Facilities & Operations Committee Meeting September 2026

RE: North Penn High School BP-2
Change Order Request #23 ASI 01 – Additional Shaft wall

PROJECT: *(name and address)* North Penn High School Renovations Bid Package 2	**CONTRACT INFORMATION:** Contract For: Mechanical Construction Date: 08-14-2026	**ASI INFORMATION:** ASI Number: 01 Date: 01-20-2026
OWNER: *(name and address)* North Penn School District 401 E. Hancock Street Landsdale, PA 19446	**ARCHITECT:** *(name and address)* Hord Coplan Macht, Inc. d/b/a SCHRADERGROUP Studio 555 E. North Lane, Suite 5100 Conshohocken , PA 19428	**CONTRACTOR:** *(name and address)* JBM Mechanical, Inc 3273 Gun Club Road Nazareth, PA 18064

Drawing Title:
EXTERIOR STAIR DEMOLITION

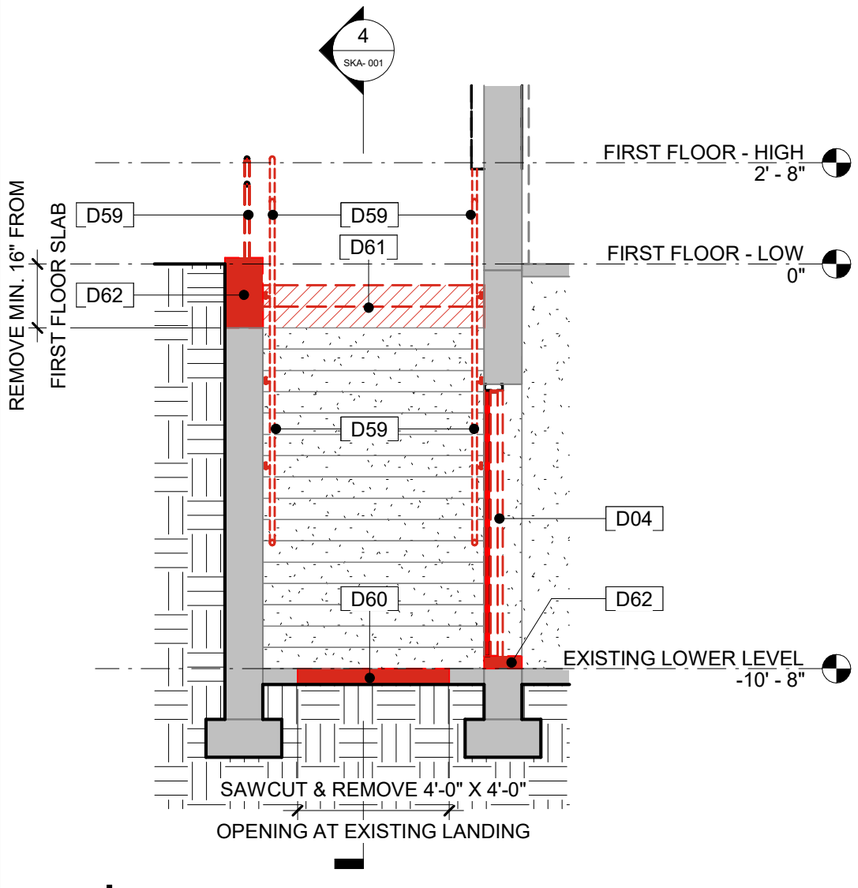
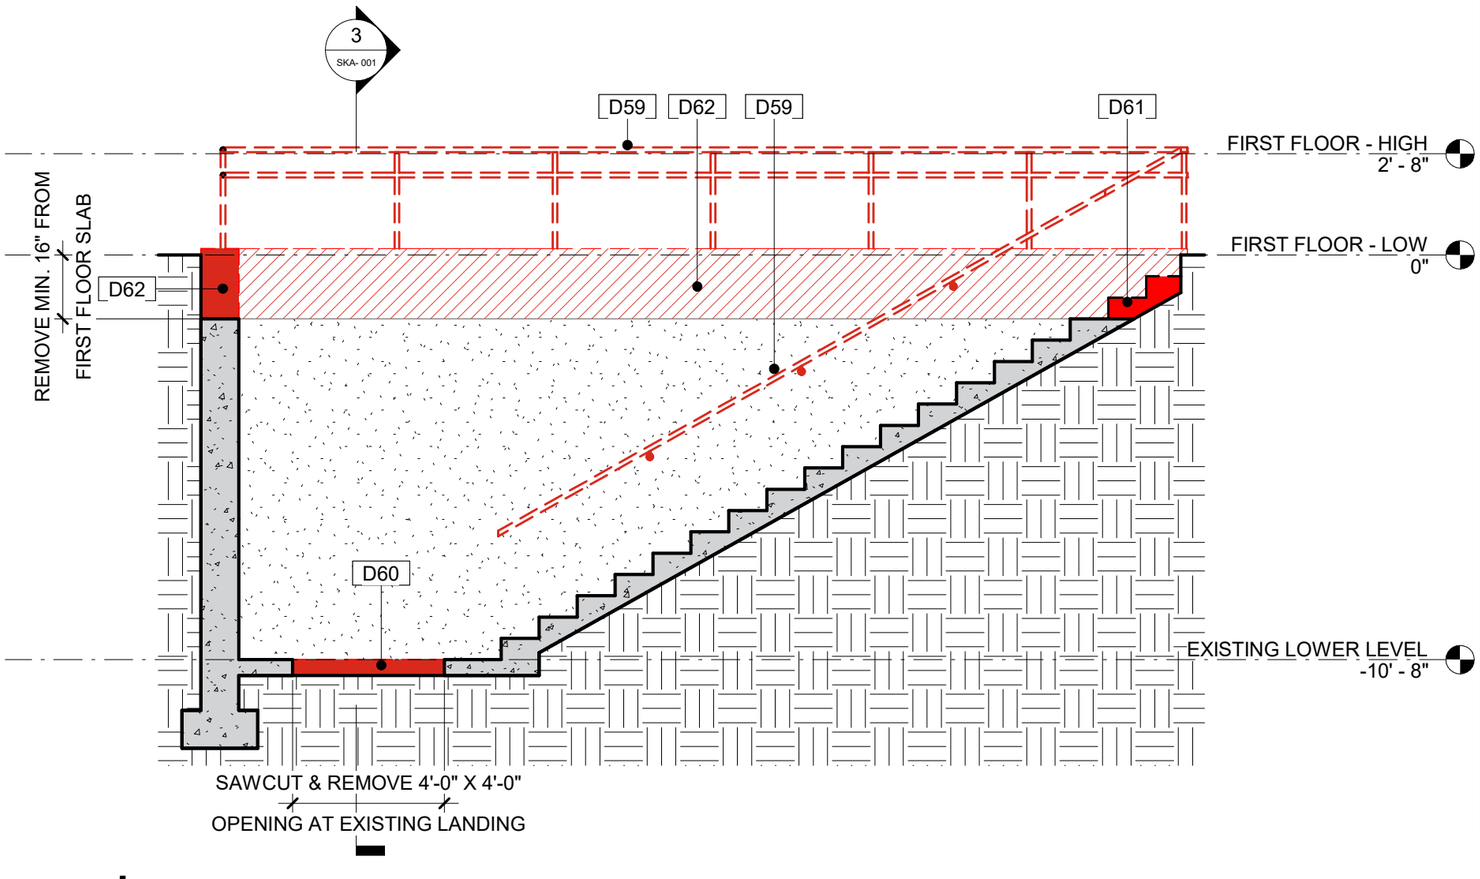
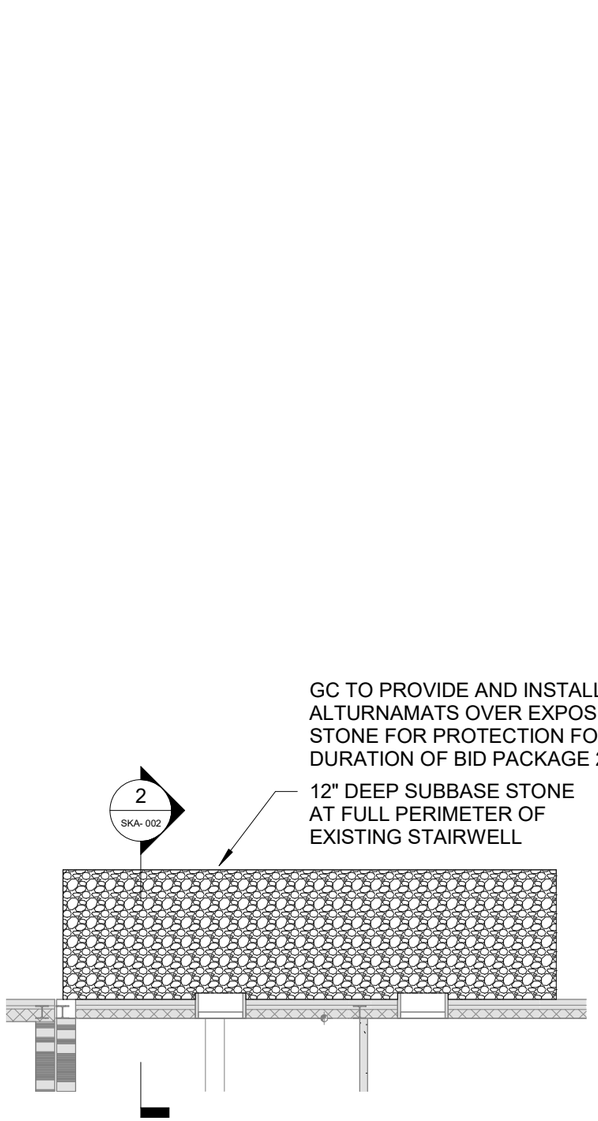
EXTRA WORK/CHANGE DESCRIPTION:
Hammer Steps and Wall below grade, leave in place to be buried. Hammer bottom of stairs to allow drainage.
NO MATERIAL WILL BE REMOVED FROM SITE. BACKFILLING OF STAIRS IS NOT INCLUDED IN THIS PRICE
NO SAW CUTTING IS INCLUDED. Surface will be rough as they will be broken off and not neatly removed.

ASI 03.1GC: Courtyard Grading Revisions (Per RFI GC-008 Courtyard Grading)
ASI 03.2GC: H-Pod Stairwell Demolition & Infill
ASI 03.3GC: Area B Equipment Yard Storm Inlet & Concrete Paving

3.03 Sketch BP2-SKA-001; ADD sketch BP2-SKA-001 dated 03/16/2026.
3.04 Sketch BP2-SKA-002; ADD sketch BP2-SKA-002 dated 03/15/2026.
